# SAN FRANCISCO PLANNING DEPARTMENT

## Discretionary Review Abbreviated Analysis HEARING DATE: JUNE 6, 2019

*Date:* May 30, 2019  
*Case No.:* **2017-006245DRP**  
*Project Address:* **50 Seward St.**  
*Permit Application:* 2017.0419.4301  
*Zoning:* RH-2 [Residential House, Two-Family]  
40-X Height and Bulk District  
*Block/Lot:* 2701/024A  
*Project Sponsor:* Khoan Duong  
John Lum Architecture  
3246 17<sup>th</sup> Street  
San Francisco, CA 94110  
*Staff Contact:* David Winslow – (415) 575-9159  
[David.Winslow@sfgov.org](mailto:David.Winslow@sfgov.org)  
*Recommendation:* **Do not take DR and approve**

The project consists of a 7' reduction at the rear of the second story, a horizontal front addition, and a third story vertical addition to an existing 2-story (at the street) two-family residence. The proposal also includes relocating the garage and curb cut.

Fig. 1. Aerial photograph of 49 Seward and 50 Seward buildings, and neighbors, with bearing determined using GPS coordinates.

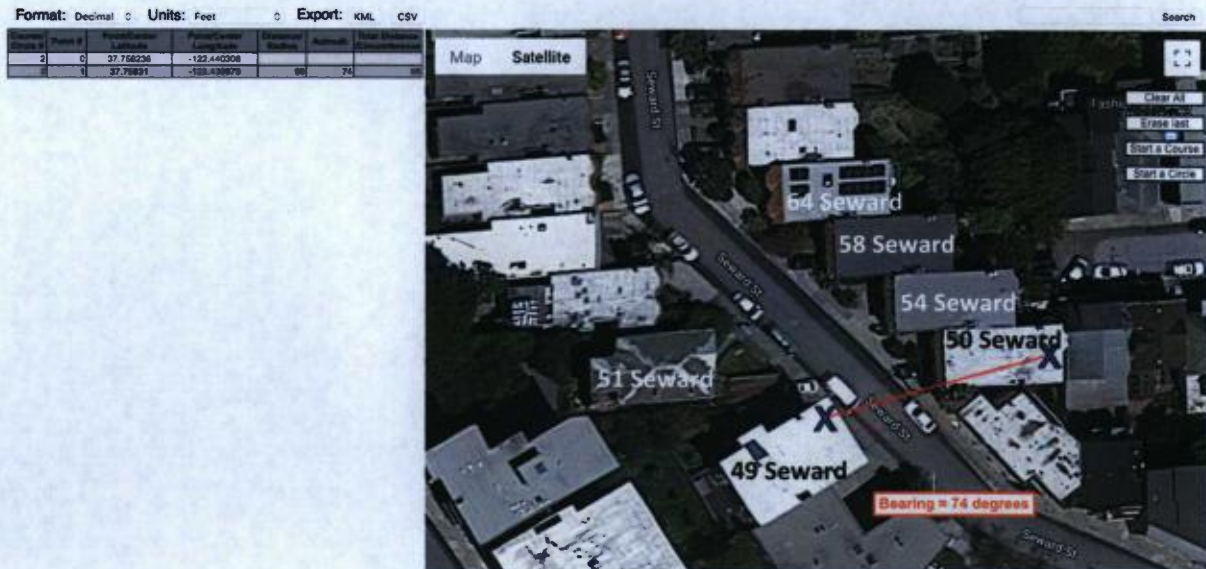
Our east-facing living room windows are the primary source of natural light into our property. Because our windows currently face unobstructed sky, we have an abundance of natural light. Please see Figure 1 which shows the compass bearing between the properties.

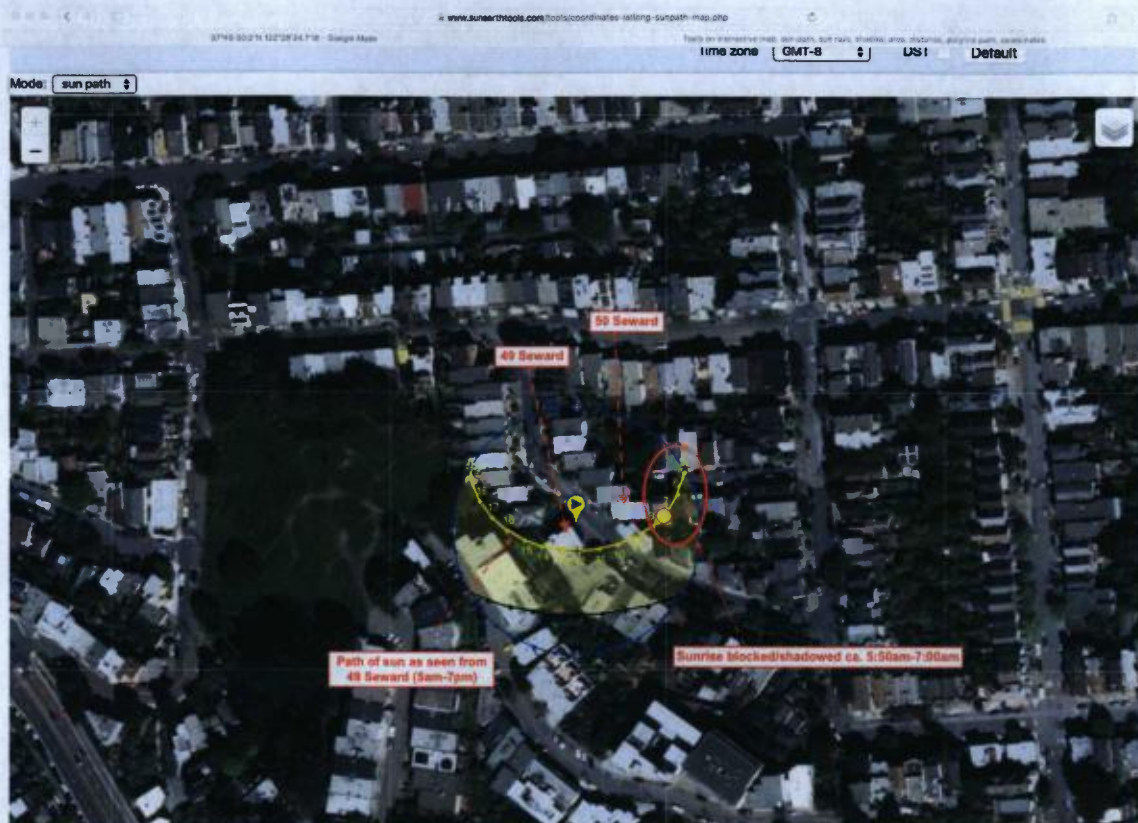
Figure 2 illustrates the sun's motion with respect to our property location.

Fig. 6. Photograph of existing building at 50 Seward and its driveway, which is large enough for parking a vehicle.

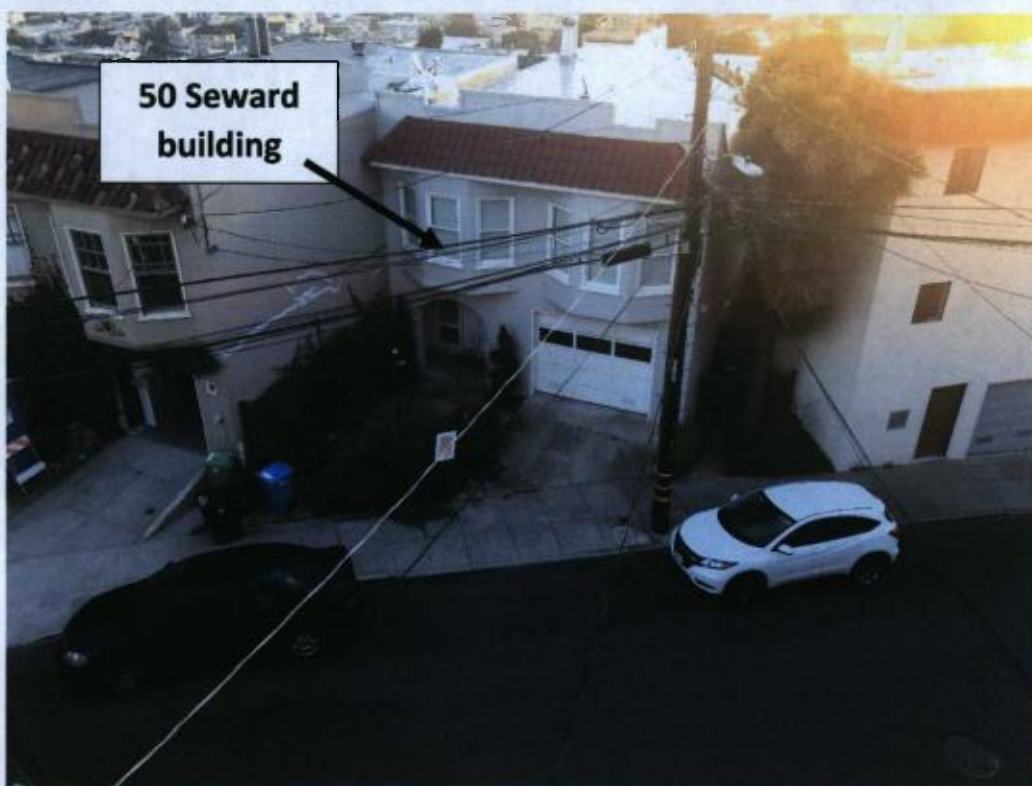
**Impact 3)** The design choice to remove the existing driveway (see Figure 6) in order to enable expansion of the building's footprint means that the 50 Seward owners will only be able to store one vehicle on their property. The owners of 50 Seward St. own two vehicles. After construction, their second vehicle would therefore need to be parked on the street. Since the proposed plans include the addition of a second housing unit having 2 bedrooms, it is reasonable to assume that the occupants of that second unit may also own two or more vehicles. The proposed plans would likely result in at least three more vehicles being parked on Seward St. and environs. Considering the narrowness of Seward St. (Figure 7) and the limited parking available in the neighborhood, the proposed plans will impact the neighbors' ability to park vehicles.

ORIGINAL PROPOSED BUILDING SECTION (PREAPPLICATION MEETING)

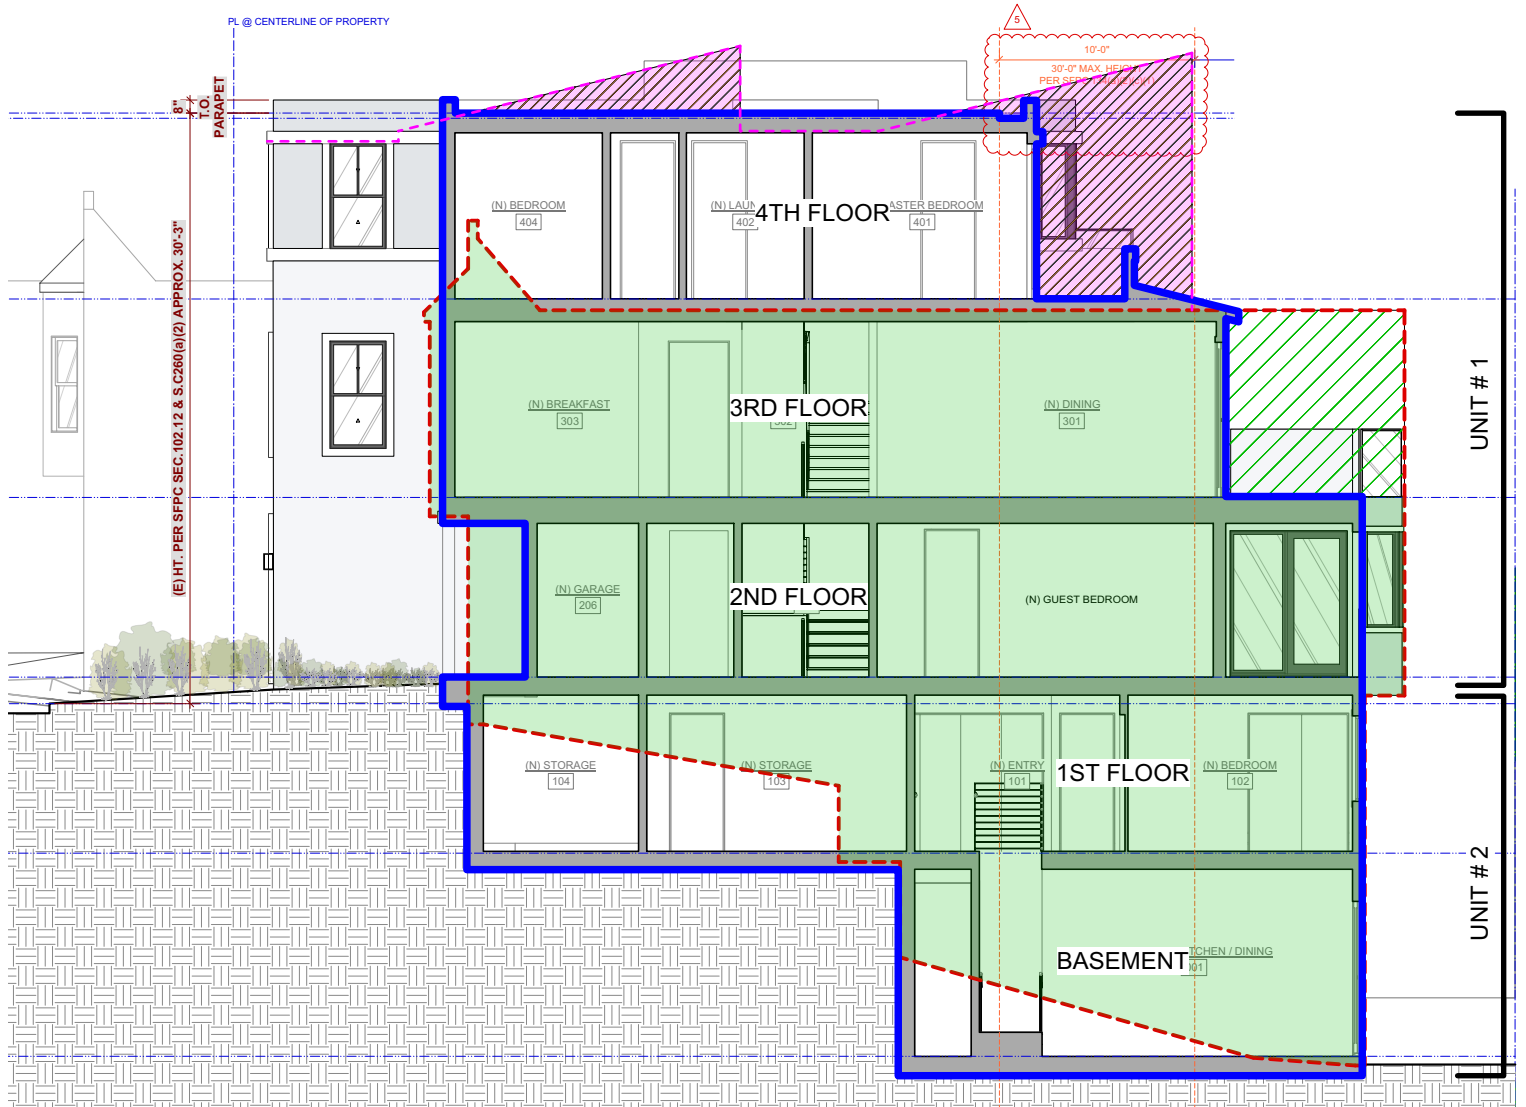
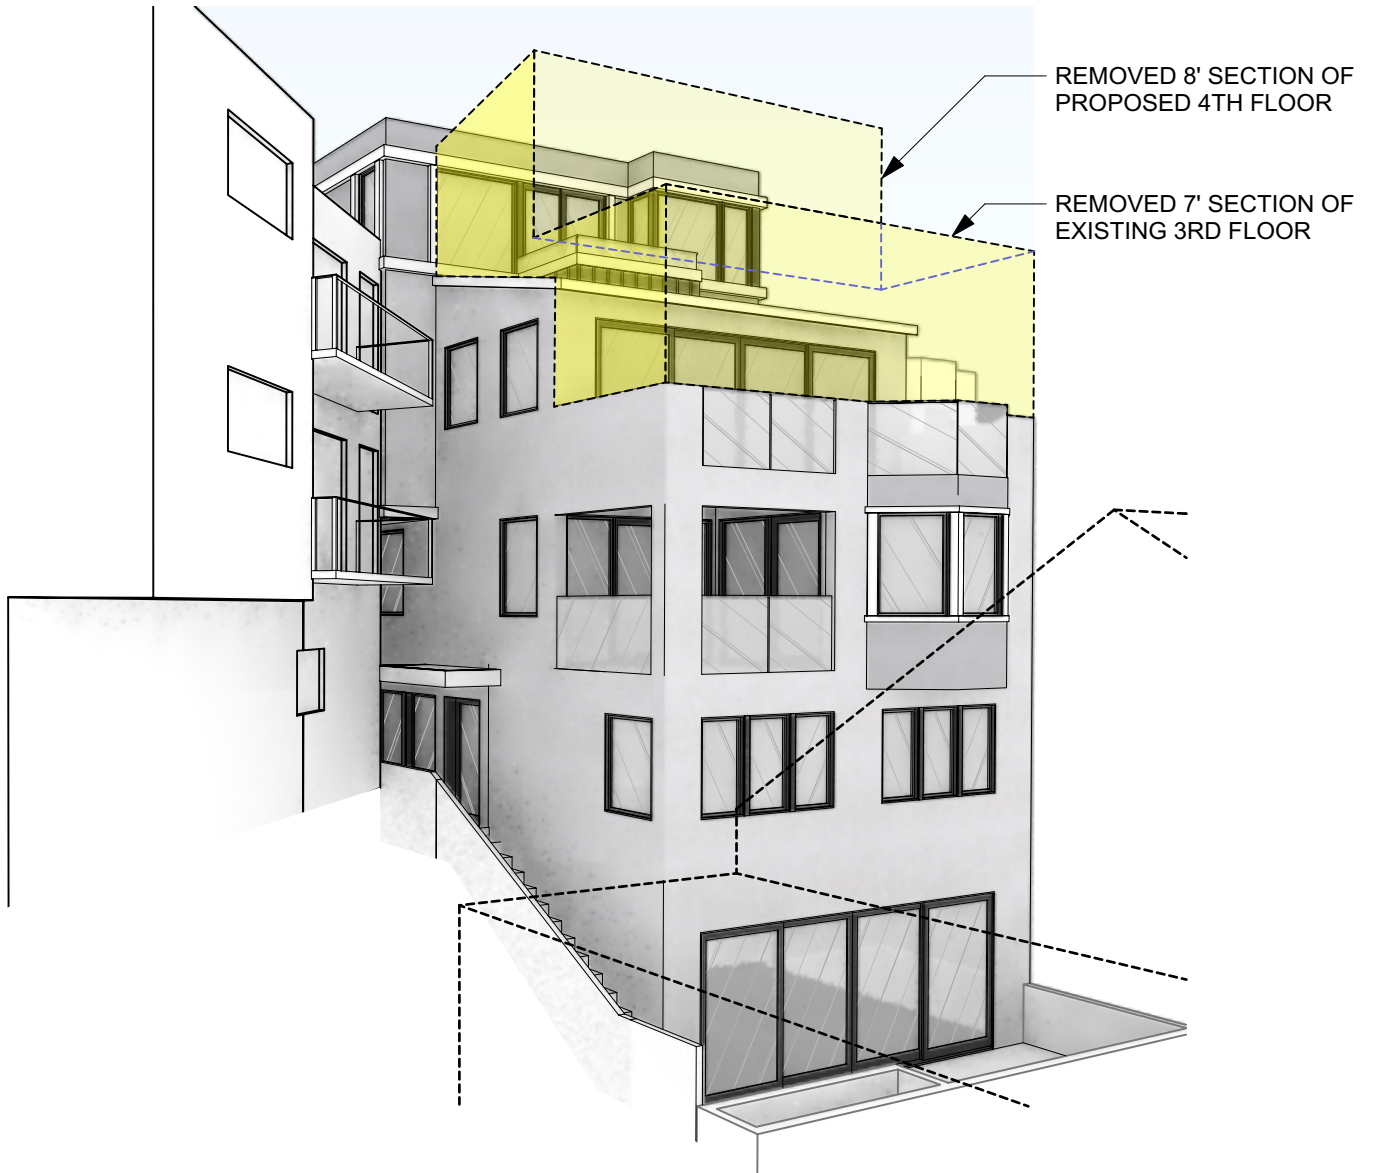
2) The Fitzgerald-Mitelmans contend that the proposed project will affect their light and air even though their unit is southwest of the Subject Property and is not located directly across the street but is diagonal. See **Exhibit 4**. Their unit's finished floor is 10" lower than the proposed roof of the Subject Property and hence the effect to their sunlight is minimal and only occurs at sunrise between 5:48 am to 6:03am during the summer. The attached sun study on **Exhibit 5** demonstrates the effect. Contrary to their assertion, the original Project submittal was modified, replacing a sloped roof with a flat roof to minimize the effect to their view.
